IN RE THE GENERAL ADJUDICATION
OF RIGHTS TO THE USE OF WATER FROM
THE SNAKE RIVER BASIN WATER SYSTEM.

NOTICE OF CLAIM TO A WATER RIGHT
ACQUIRED UNDER STATE LAW

IDAHO DEPARTMENT OF WATER RESOURCES
PRELIMINARY RECOMMENDATION OF WATER RIGHTS ACQUIRED UNDER STATE LAW

Recommendation review of Ingram water rights on Warm Spring Creek

72-10141 et.al.

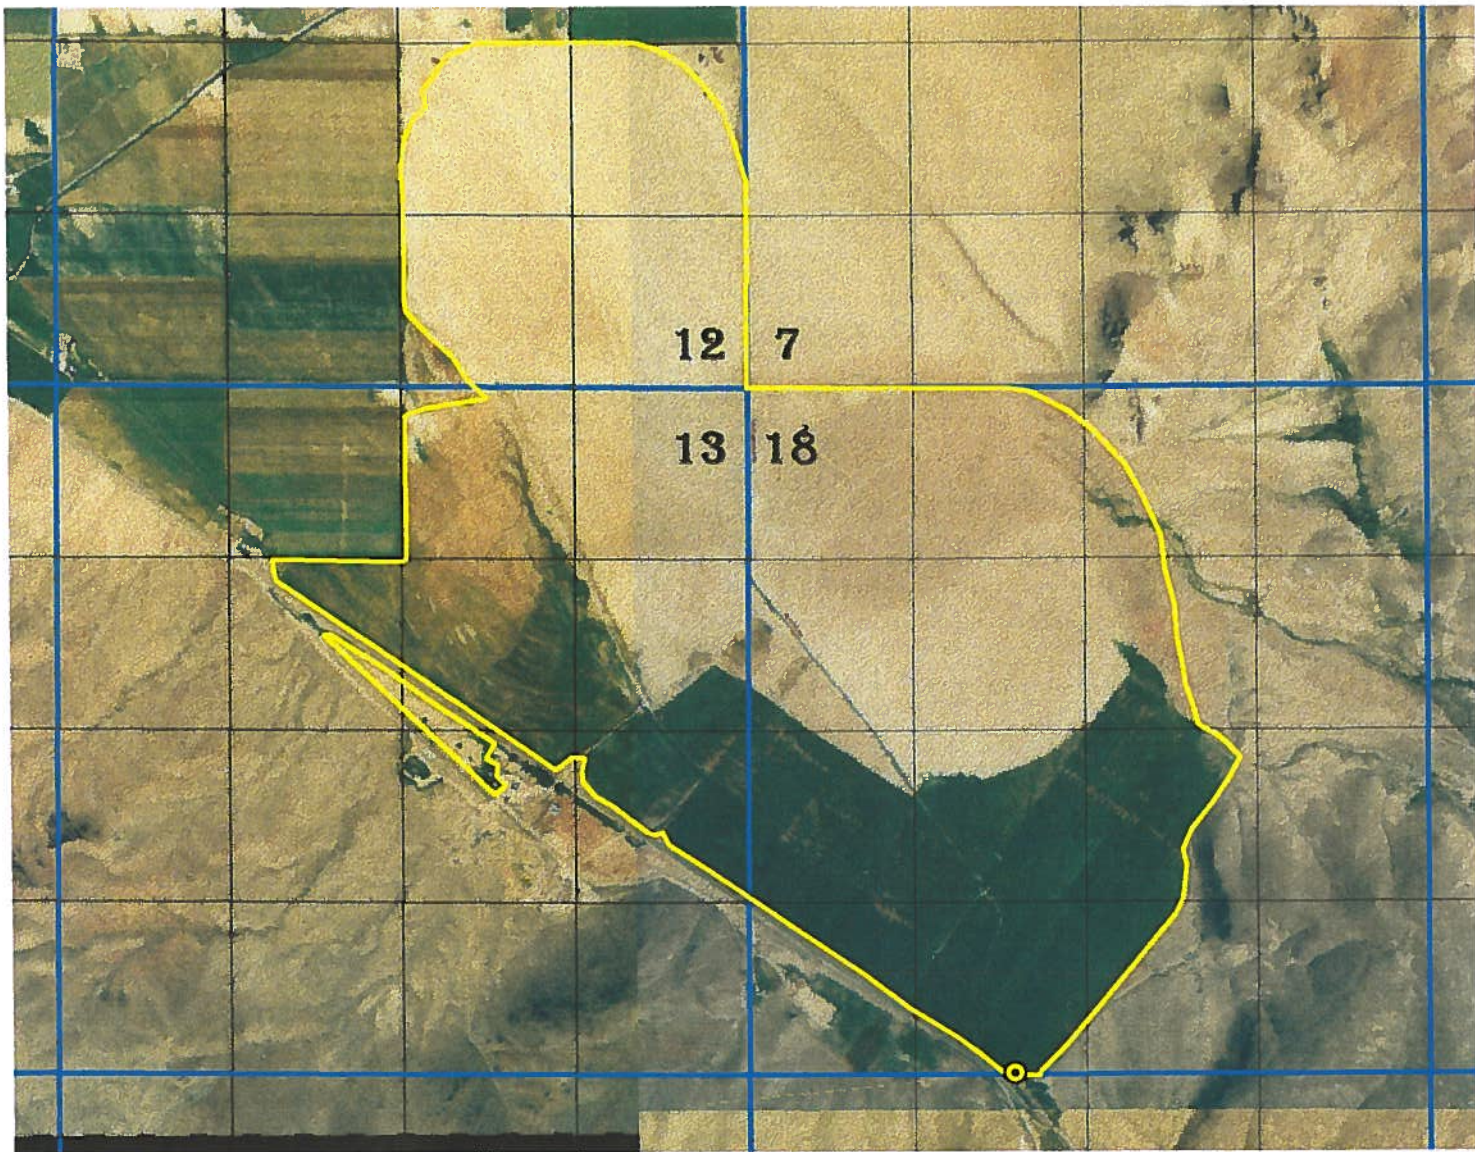
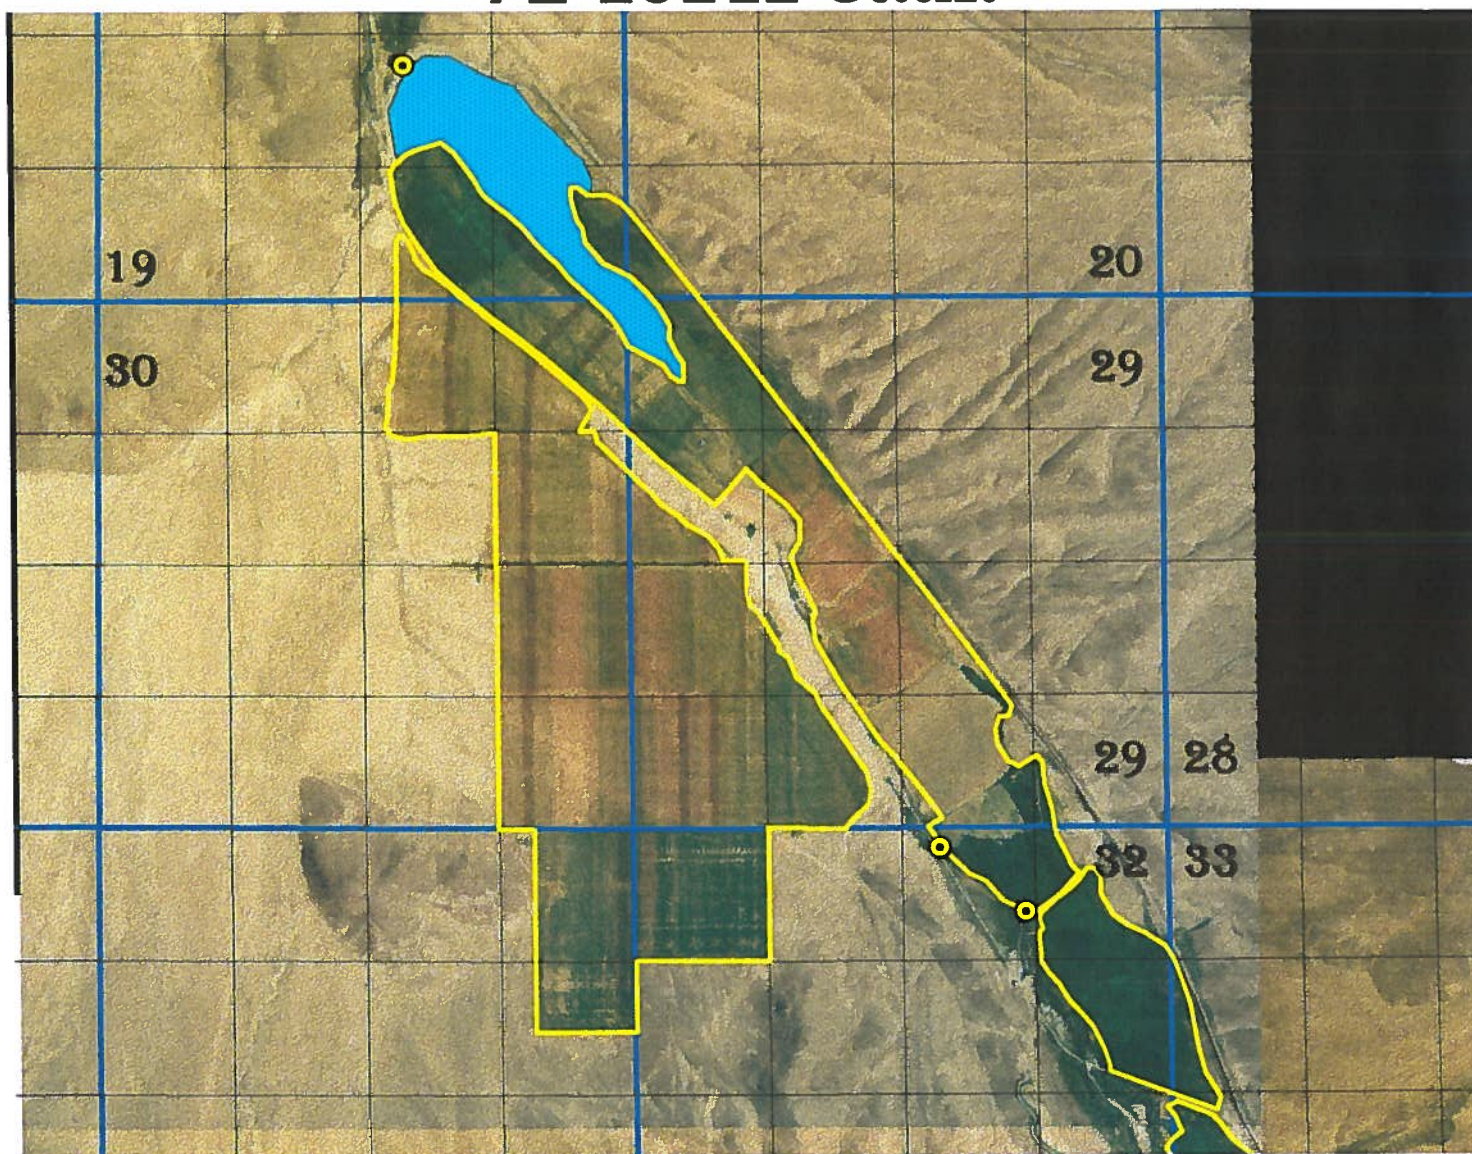
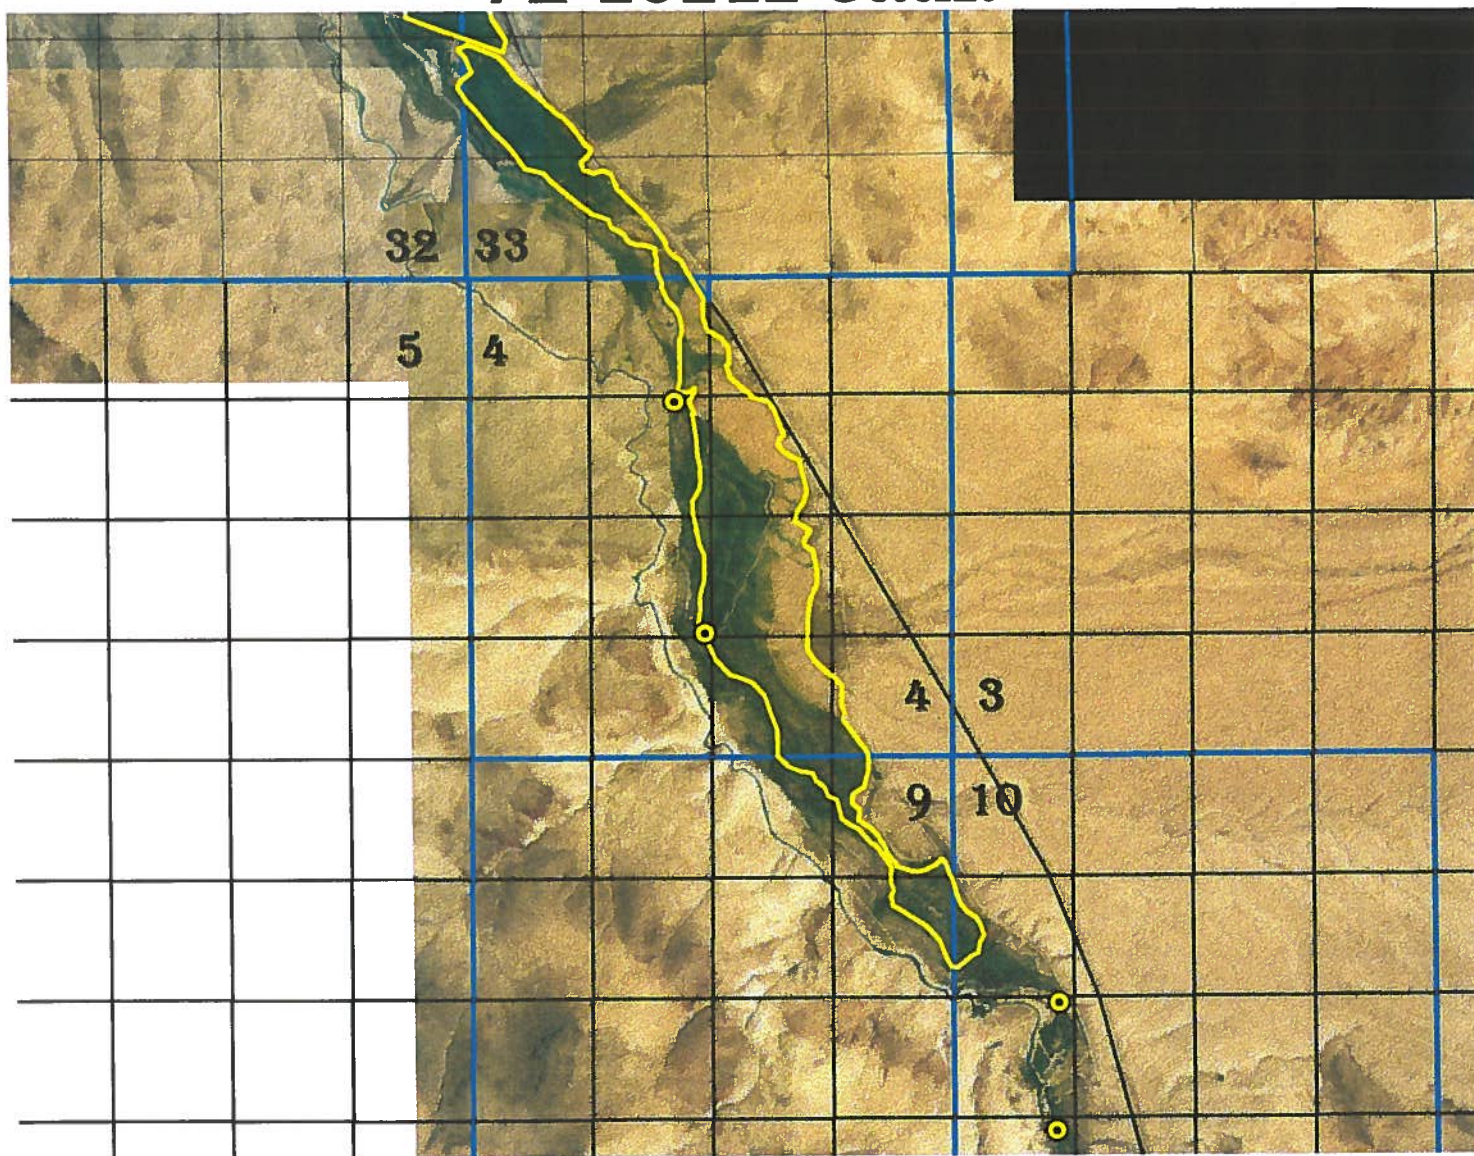
POD's: Points of Diversion as claimed by Mr. Ingram in the SRBA appear to include several re-diversions of the same waters. Those PODs listed in the recommendation show diversions of actual live stream flows. Re-diversions are not listed in the recommendations.

POU & Acres: Place of use very closely matches that of the boundaries drawn by Mr. Ingram on the attached ASCS map sheets. This information, along with the GIS data used by IDWR, was combined to obtain the most accurate place of use description available. Actual acreage was then calculated using the Arc-View software used by IDWR and I found 1515 acres of irrigation for these claims. These claims all describe the same entire POU and will be recommended as such, except for the claim for reservoir storage, A72-04096.
